REF: SUP-6008-18

SUBJECT: Special Use Permit for a gas station and grocery store at 3516 Airport Highway

LANDSCAPE PLAN

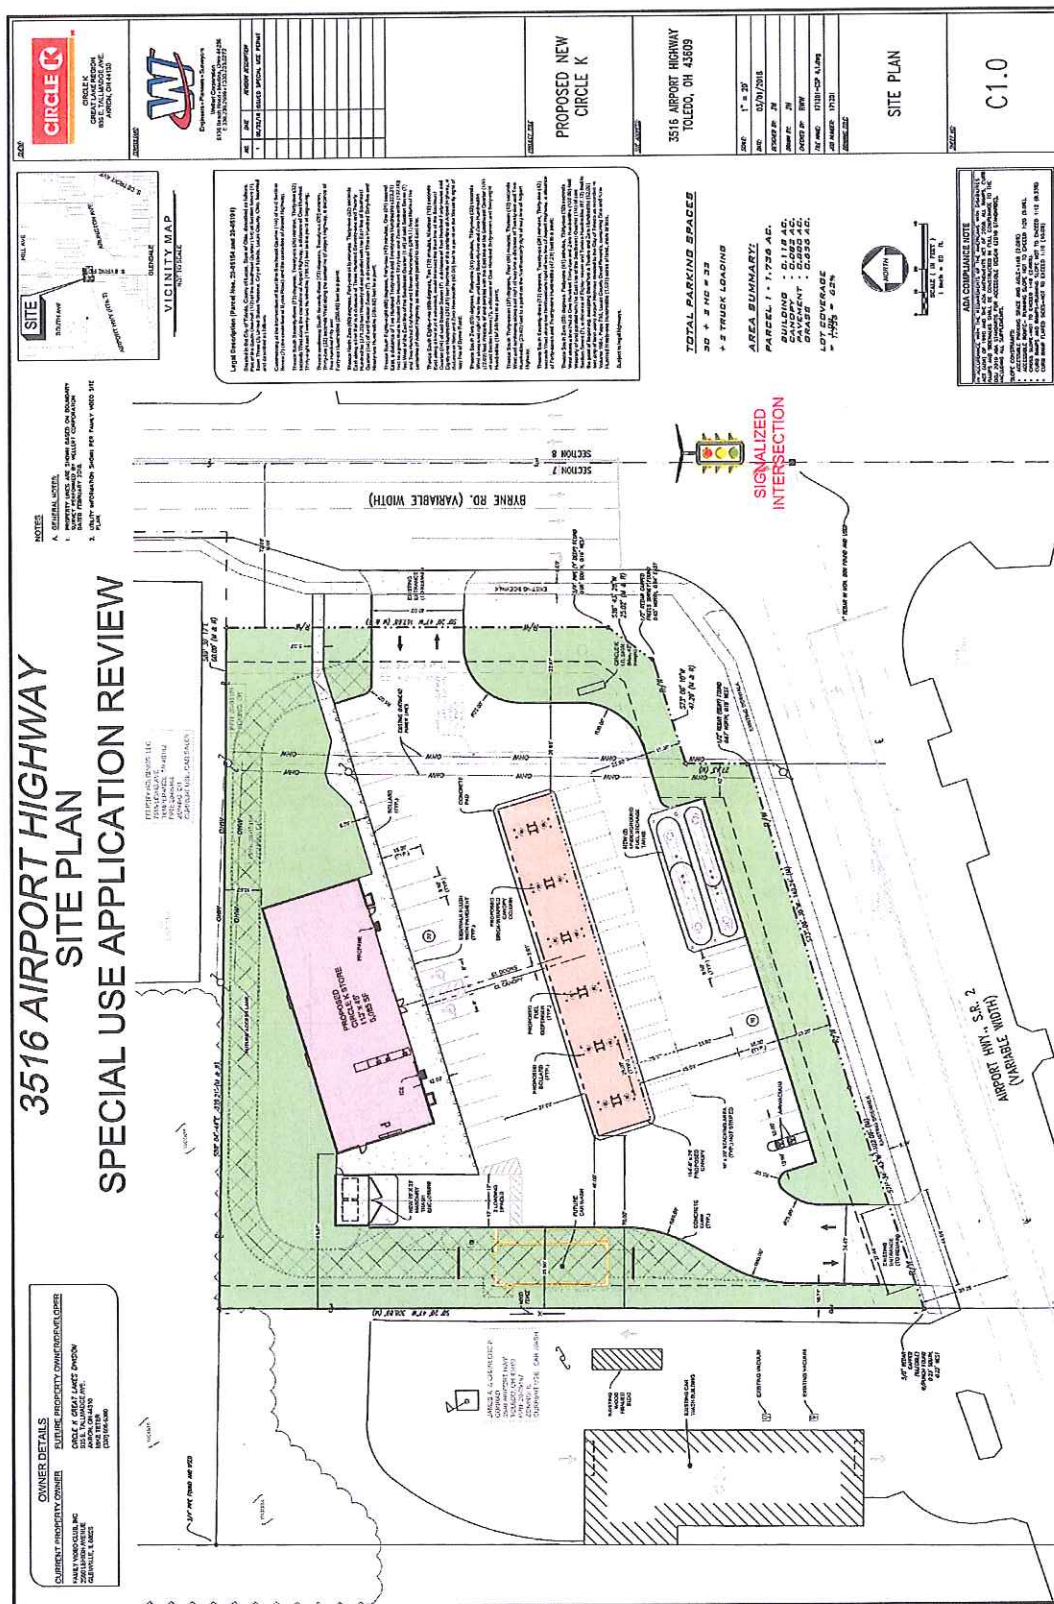
- a. A fifteen (15') foot wide greenbelt is required along the South Byrne Road and Airport Highway frontages and must be out of the right-of-way. Calculations conclude that a total of ten (10) trees are required in the frontage greenbelt along South Byrne Road and seven (7) trees are required along Airport Highway. Trees are not required to be evenly spaced and may be clustered. **(The number and species of trees are not acceptable as submitted on the landscape plan. A revised landscape plan shall be submitted showing compliance);**

- d. Foundation plantings shall be added at the main building's entrance. **(Not acceptable as shown on the landscape plan. A revised landscape plan shall be submitted showing compliance);**

RENDERING (PERSPECTIVE)

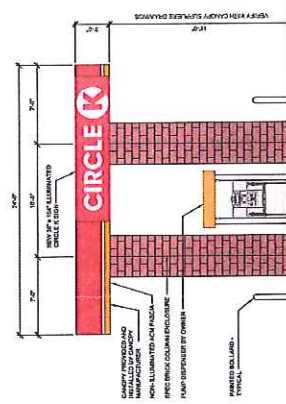
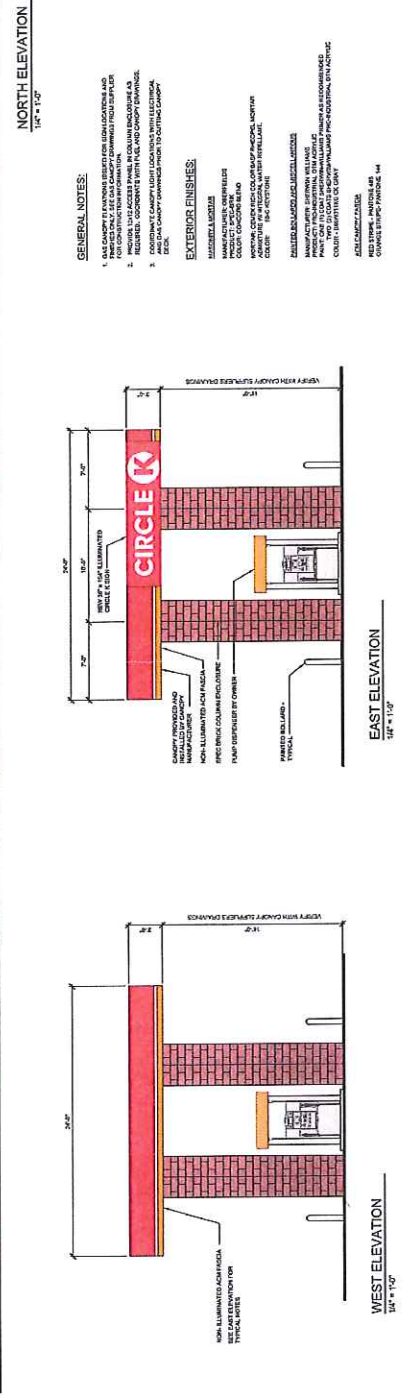
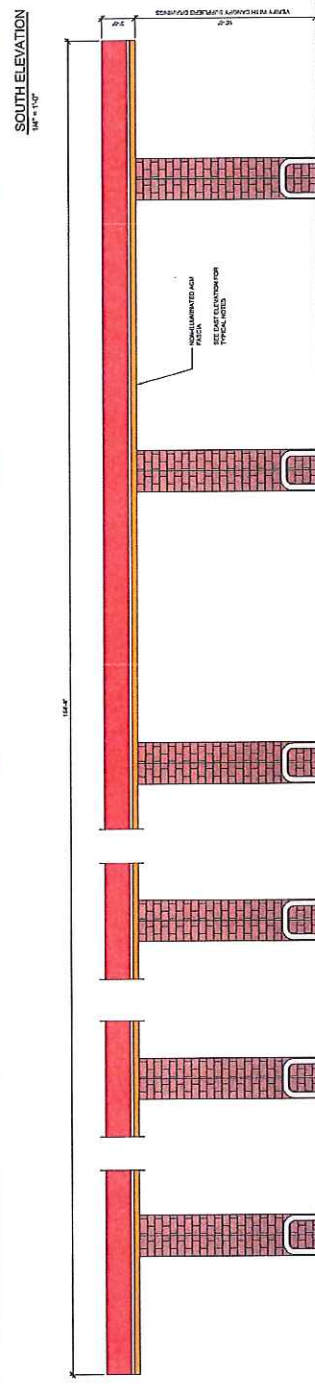
52. TMC§1109.0502 requires the use of low-reflectance, subtle, neutral or earth tone materials throughout the development. The bright red accents on the building's facades and on the bollards located in front of the building are not in compliance. **(Not acceptable as depicted on conceptual rendering. Revised renderings shall be submitted that show compliance).**
